# VKBA 3666

Technical Bulletin – December 2015

**FORD:** KA, PUMA, FIESTA IV, ESCORT VII, ESCORT CLASSIC.  
Car model codes: RB, JA, JB, JV, GAL, AAL, ABL, AFL, ALL, ANL

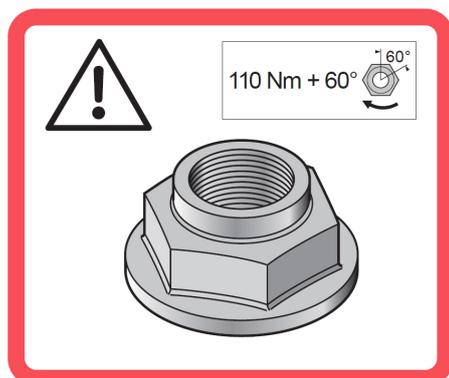
SKF has decided to change the nut in VKBA 3666, due to updated FORD OE recommendations.

**Note:** The included nut at kit VKBA 3666 has a new design and needs a different torque compared to the old design. It is crucial to follow the instructions when torquing the new nut since this is a **safety aspect**. See torque values stated at the warning label below.

New design

Old design

Caution, when fitting the wheel bearing kit VKBA 3666, it's mandatory to use the new nut included in the kit. Never reuse an old nut!
